ADDENDUM NO. 1

Sugar Land Regional Airport - Rebid

Addendum No. 1

Project: Terminal Apron Hangar Replacement Project

SHEET NAME: Proposed Elevations Base Bid

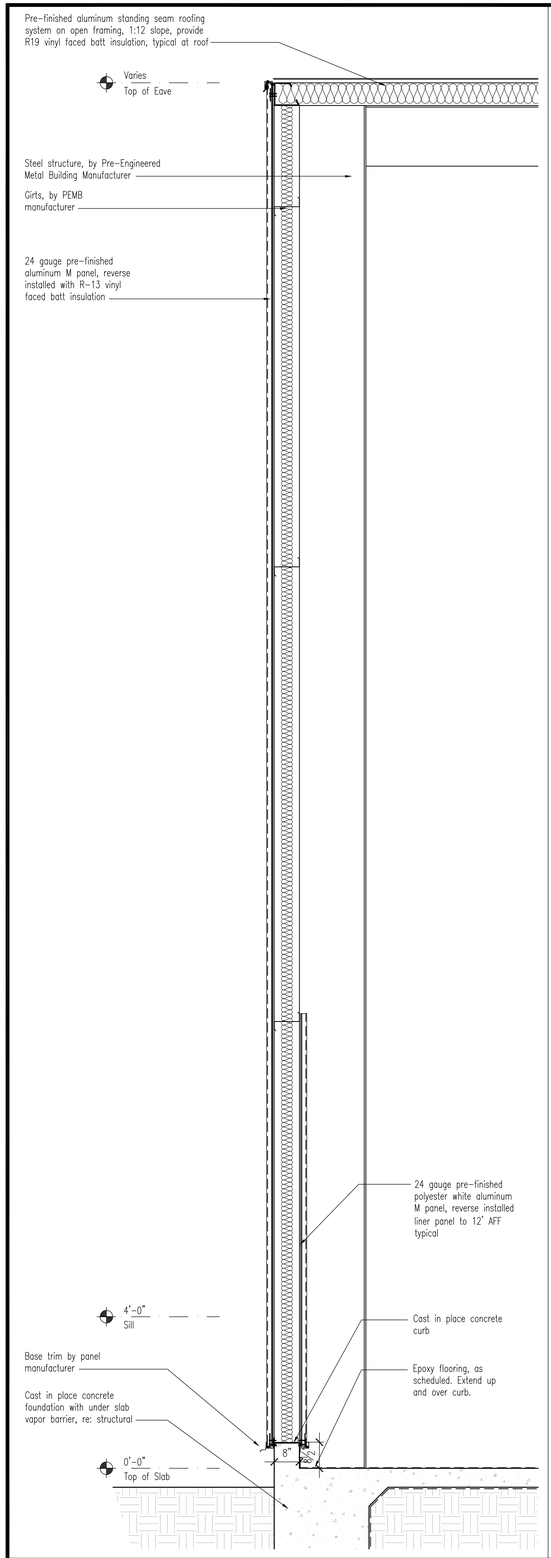
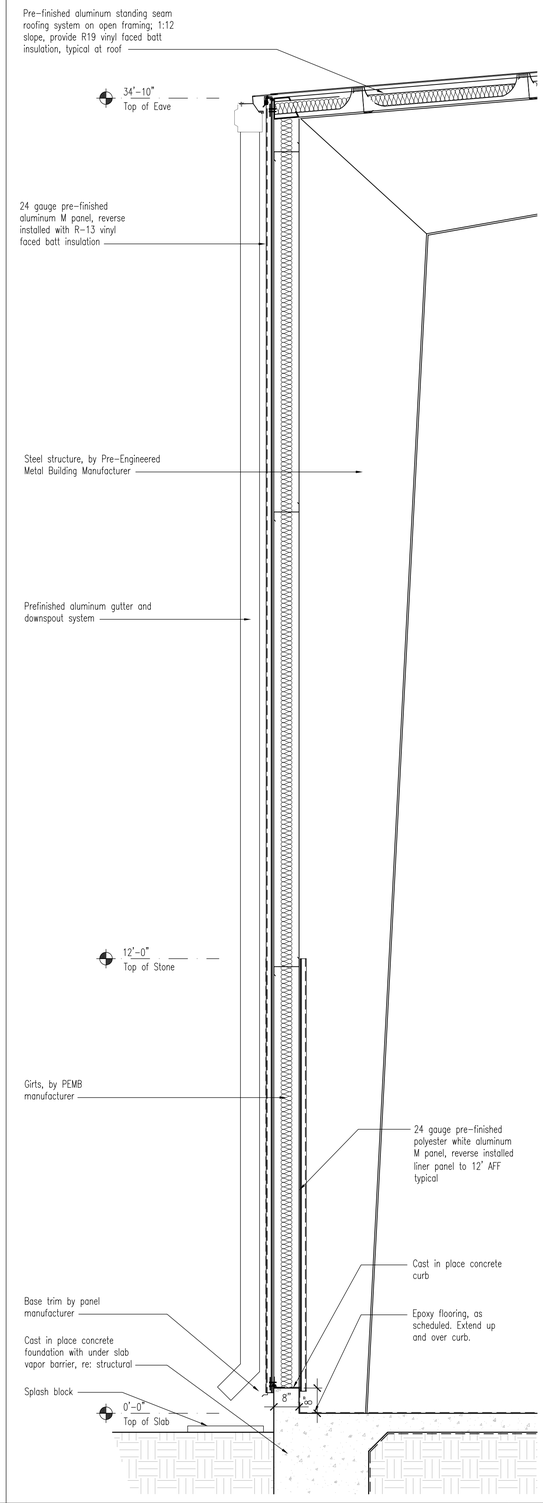
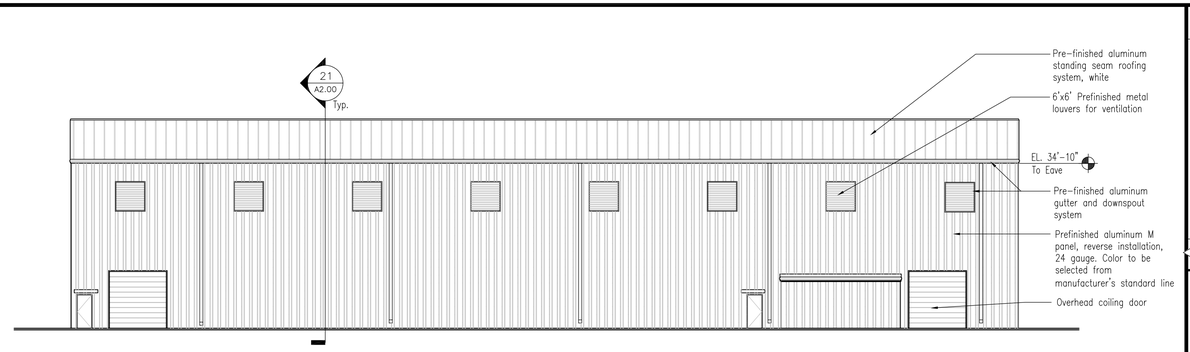
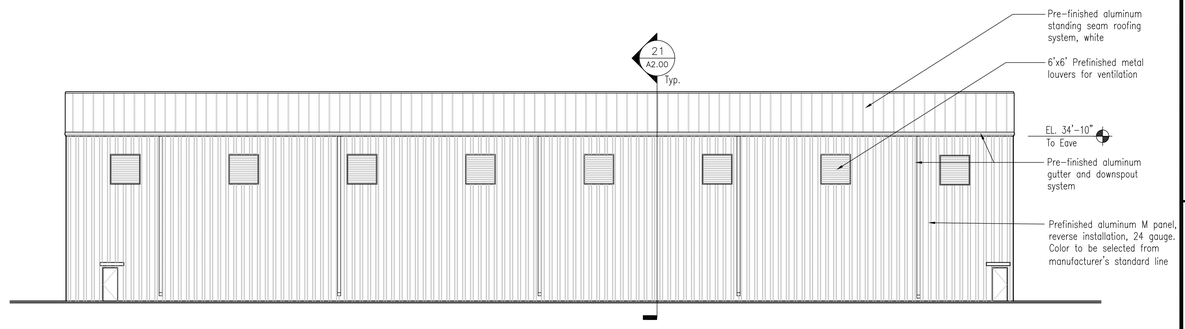
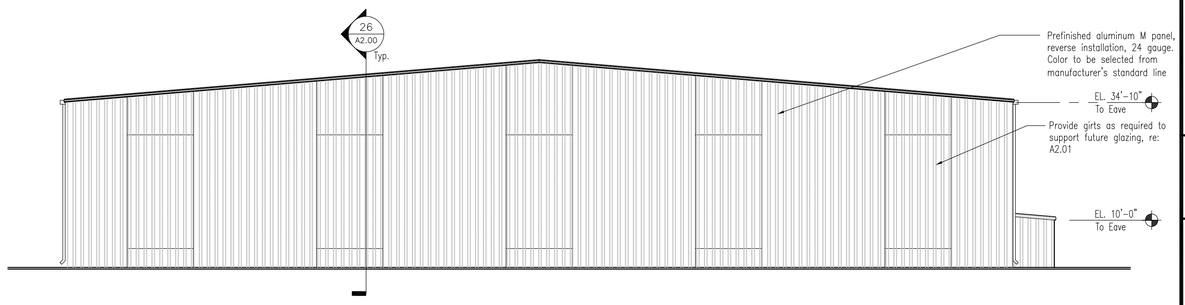
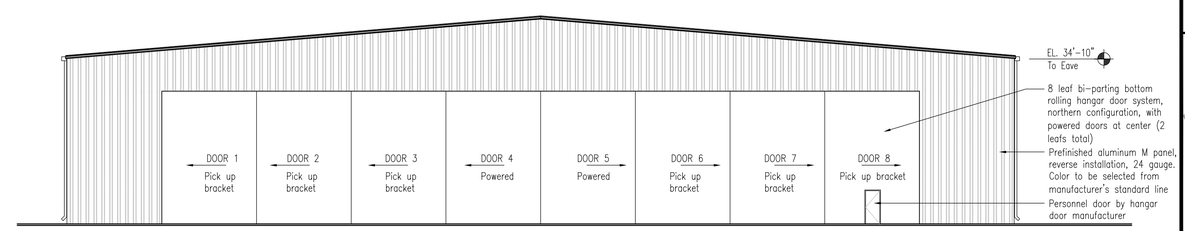
A. Plan Sheet A2.00, Proposed Elevations Base Bid

1. Add the attached Plan Sheet A2.00, Proposed Elevations Base Bid

5. Question: What is intended wall panel type on West (Left End Wall) wall at sides and gable above sliding door opening? Elevations show "Pre-Finished Galvanized Aluminum Panels." Should this be 24ga PBR screw down wall panel? Or will this be Insulated Wall Panel?
   Response: Wall is M-panel, reverse installed, typical for base bid as well as all alternate scenarios.

6. Question: Spec section 083416-4 under note 9 calls for exterior and interior siding and trim and insulation for Norco door leaves to be provided by building manufacturer. What are panel types required for the door leaves?
   Response: The panels on the façade will be M panel, as indicated on the revised drawings.

14. Question: For the interior liner panel what are its limits from the finished floor elevation? Will the liner panel extend up the full length of the wall or will it go up to 8 feet?
    Response: Refer to revised sheets A2.00 and A2.01 included in this email.

SHEET NAME: Proposed Elevations

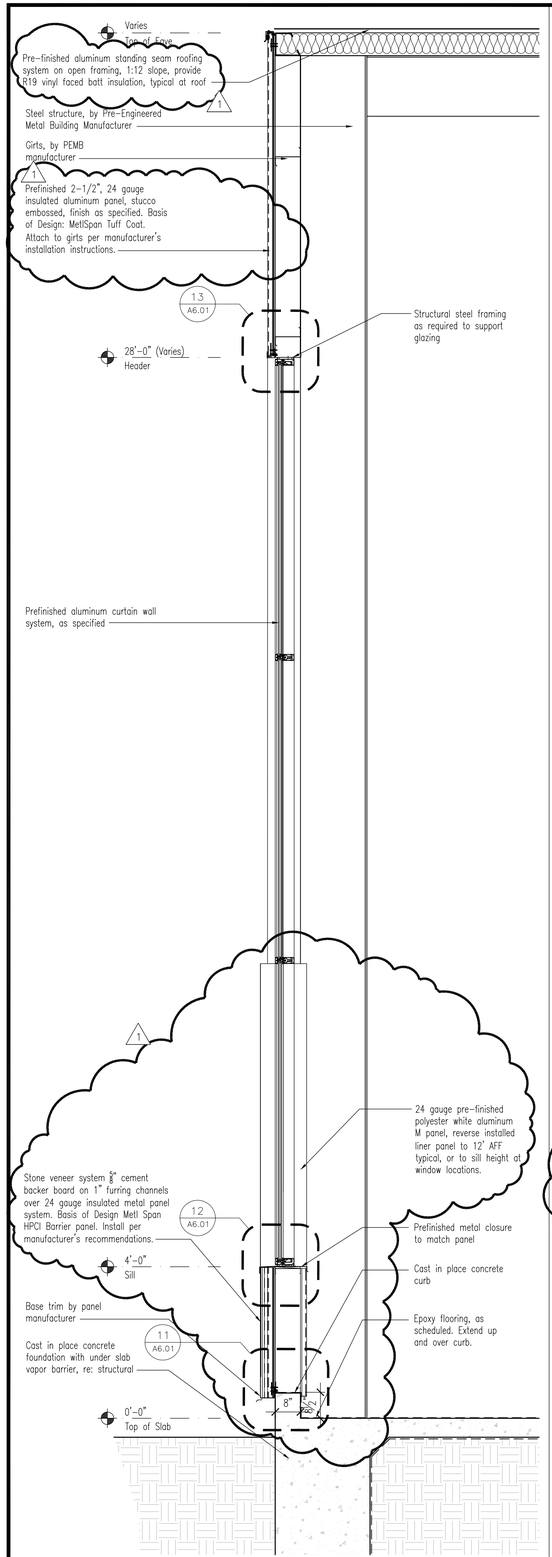
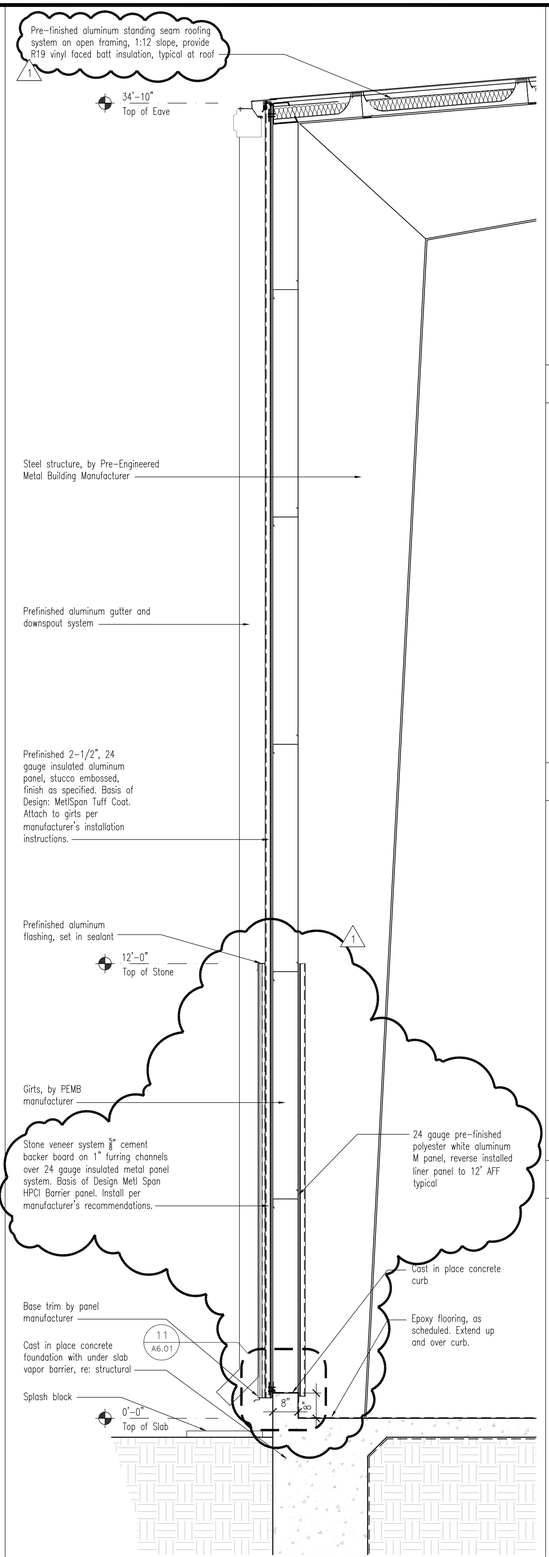
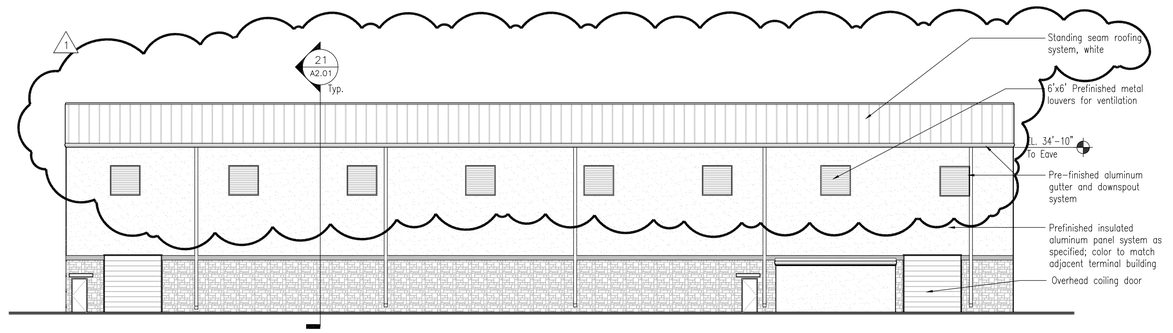
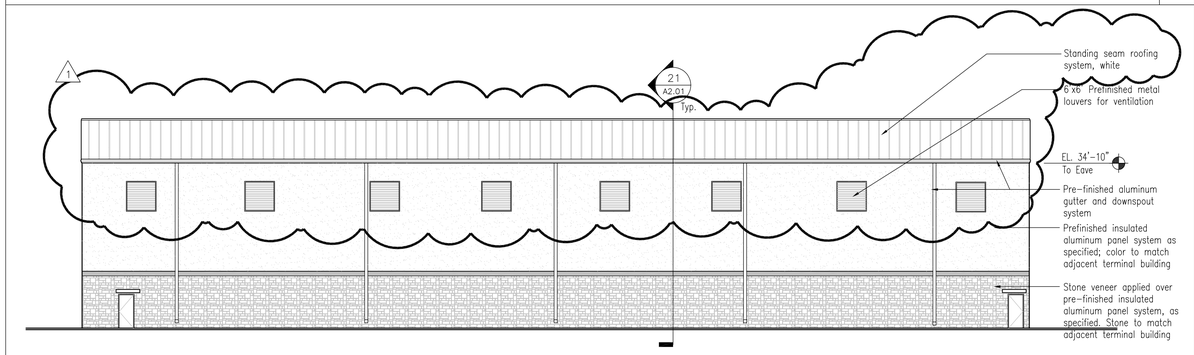
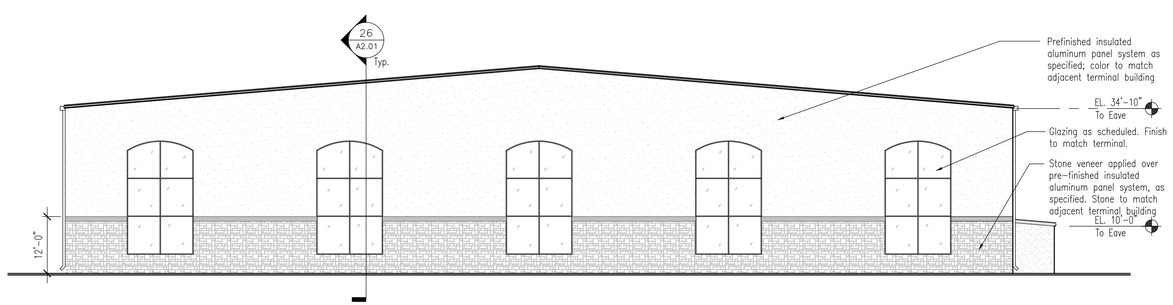
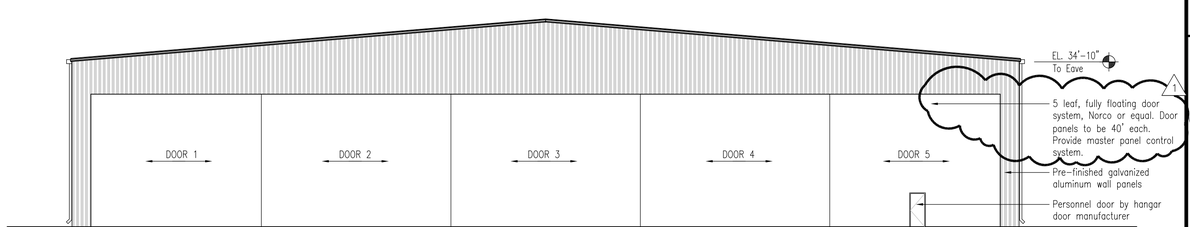
B. Plan Sheet A2.01, Proposed Elevations

1. Replace with the attached Revised Plan Sheet A2.01, Proposed Elevations

7. Question: Elevations on A2.01 and Mechanical plan M2.1 show conflicting quantity and size of louvers. Mechanical M2.1 looks like total of 16 (8 on each sidewall) openings for louvers or exhaust fans. Please verify these can be located to allow X bracing in at least two sidewall bays? Or that bracing is allowed to run behind louver? Or should we design and price for portal frame bracing?
   Response: Architectural is updated to match Mechanical. Louvers may be shifted as required within 12", and bracing is allowed to run behind louver, if necessary.

10. Question: Section 21 on drawing A2.01 shows R-38 roof insulation. Is banded insulation acceptable, or should "Simple Saver" (Fabric liner system) type system be provided?
    Response: Clarified on drawings. R 19 at roof, vinyl backed batts.
